Plympton Park LATM Project Update September 2026

Design Plan – Wattle Terrace and Arthur Street Traffic Control Changes

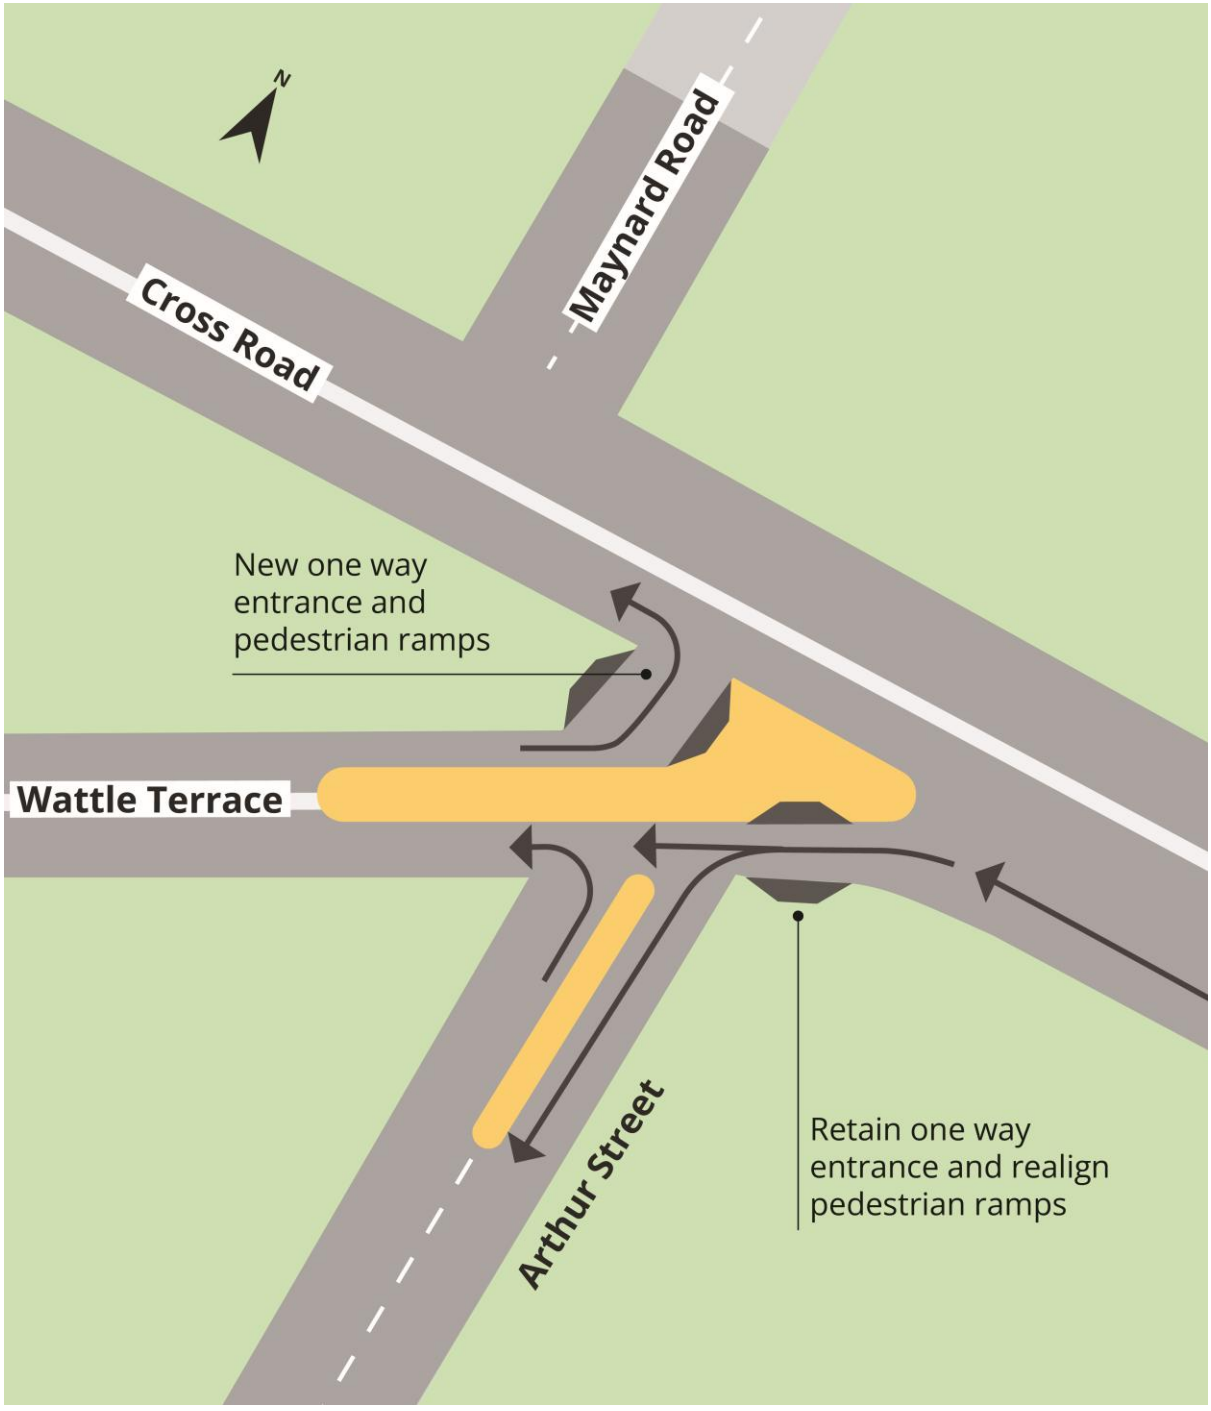
This is still being delivered, however as the project progressed through detailed design, Council identified that closing the northbound lane of Arthur Street would create access difficulties for waste collection vehicles servicing the area. We have revised the design to address this while maintaining the key traffic management objectives of the project.

- Retain the existing left turn from Arthur Street into Wattle Terrace, maintaining local access and allowing waste collection vehicles and other essential services to continue servicing the area;
- Provide the new left-turn exit from Wattle Terrace onto Cross Road; and
- Install a raised median along Wattle Terrace to prevent vehicles travelling northbound through Arthur Street to access the new exit to access Cross Road.

The revised design maintains local access between Arthur Street and Wattle Terrace while continuing to discourage non-local traffic from using Arthur Street to access Cross Road. A plan showing the revised design is provided overleaf.
